Project: IEEE P802.15 Working Group for Wireless Personal Area Networks (WPANs)

Submission Title: [Cyclic-redundancy-check Codes for Header-check Sequence]

Date Submitted: [15 Jan, 2008]

Purpose: [Modification of generator polynomial of CRCC for HCS in the baseline document]

Undetected-error probabilities as a function of bit-error rate

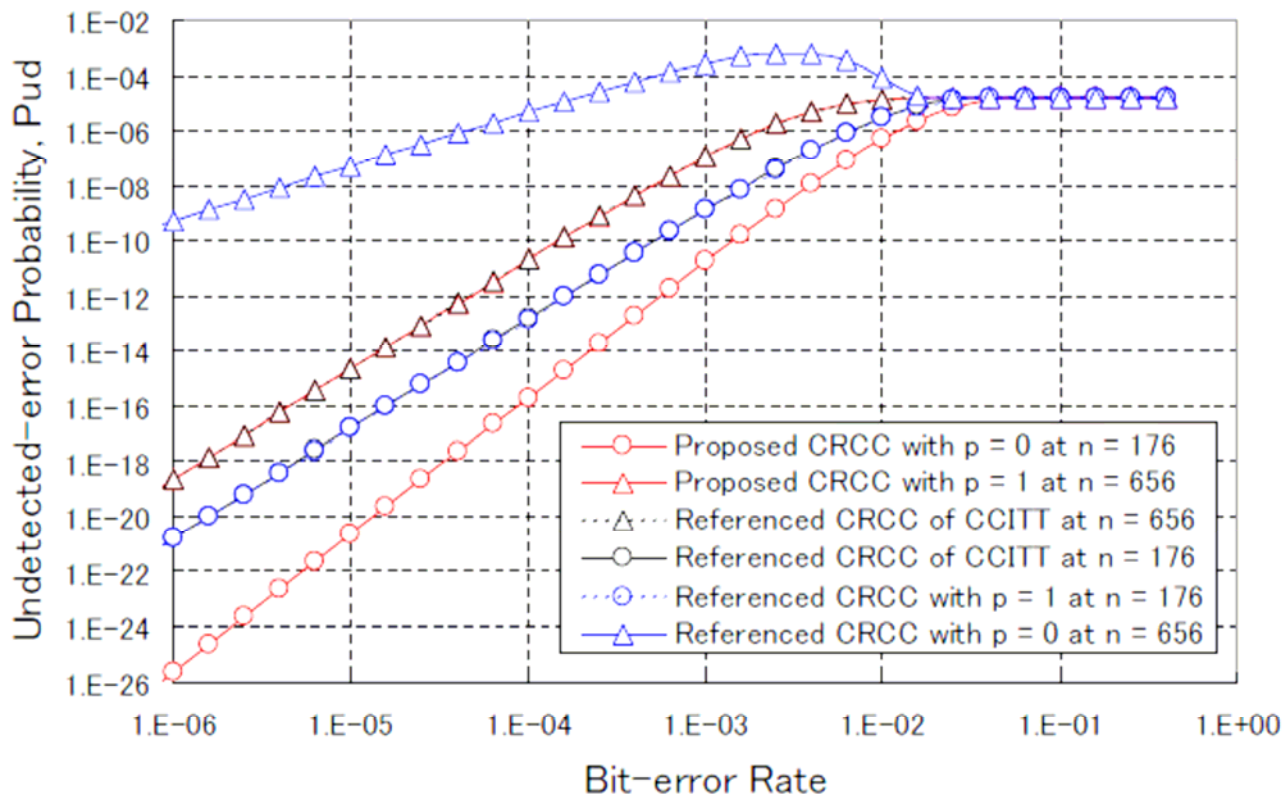
Proposed CRCC: $x^{16} + (1-p)(x^{15} + x^8 + x) + p(x^{13} + x^2) + 1$

Referenced CRCC (CCITT): $x^{16} + x^{12} + x^5 + 1$

Why the dual CRCC?

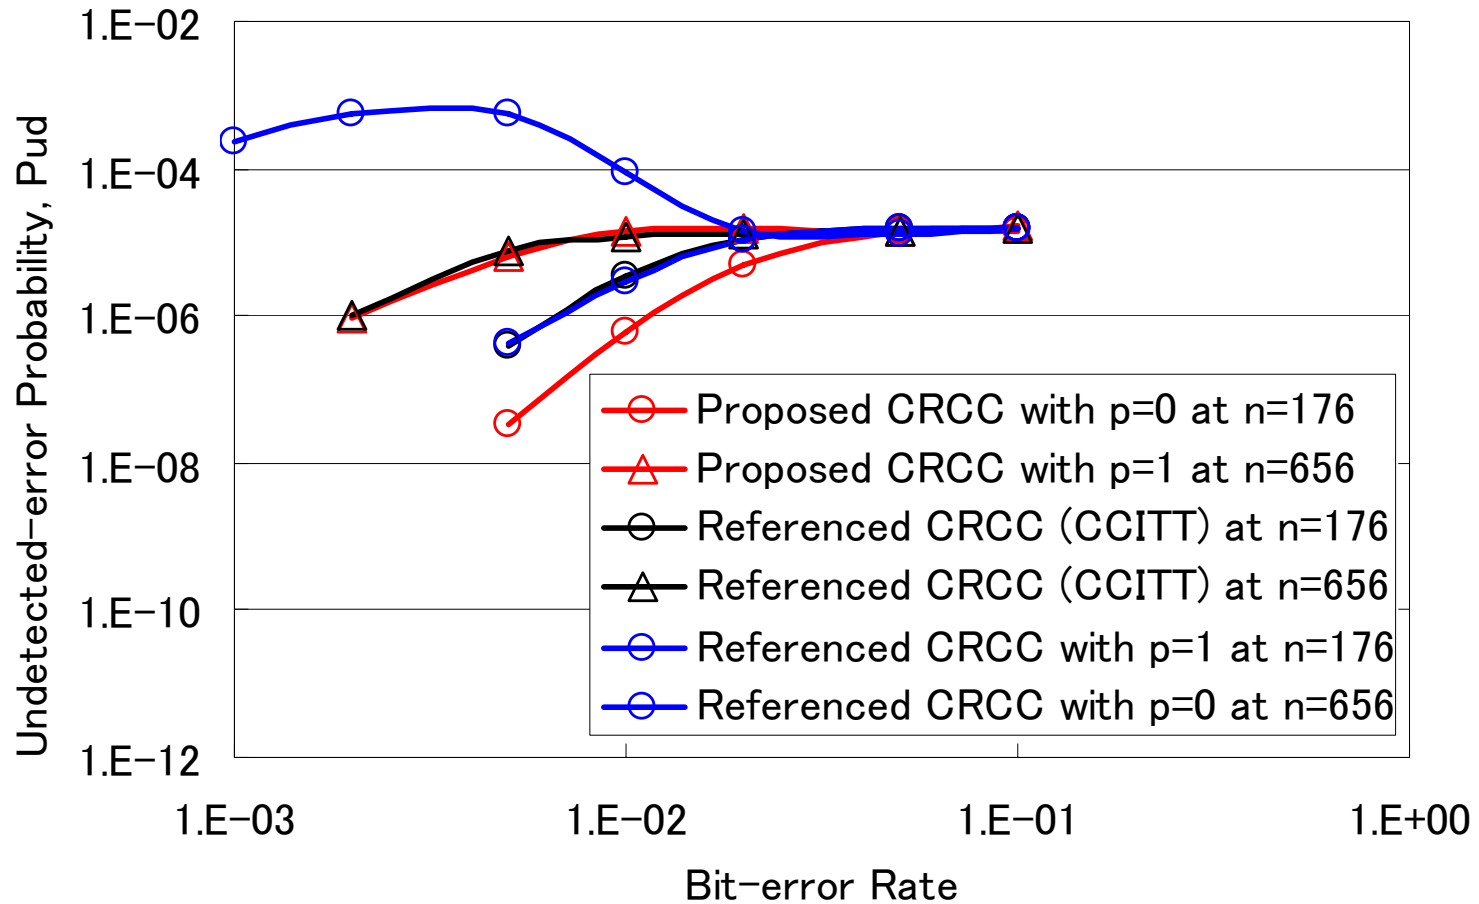
- If CRCC with $p = 0$ is used for header and subheaders, the P_{ud} at $n = 656$ is higher than that of CCITT.
- If CRCC with $p = 1$ is used for header and subheaders, the P_{ud} at $n = 176$ is 4.6% lower than that of CCITT. However, the P_{ud} of proposed CRCC with $p = 0$ at $n = 176$ is 5 digits lower than that of CCITT.

It is better to change the value of " p " depending on the header.

A block diagram of encoder

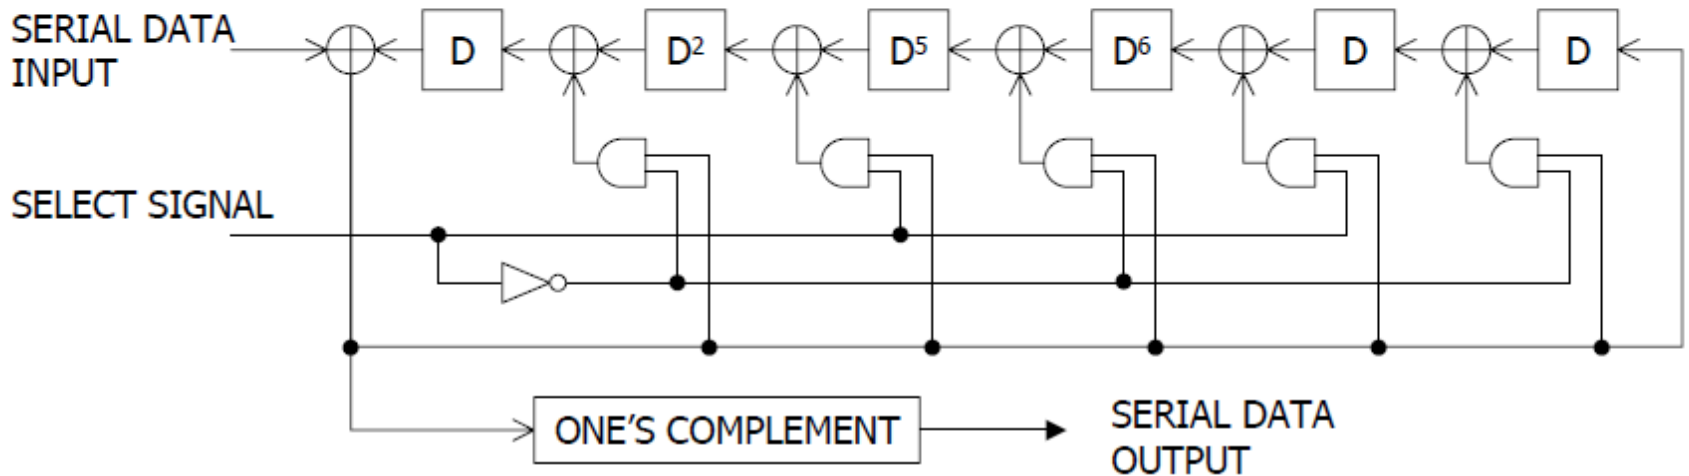
The increase of size of hardware of the serial encoder for the dual CRCC is **just 8 gates** compared with that for single CRCC.

Proposed generator polynomial: $G(x) = x^{16} + (1-p)(x^{15} + x^8 + x) + p(x^{13} + x^2) + 1$
 $p = 0$: for combined PHY and MAC headers
 $p = 1$: for MAC subheaders
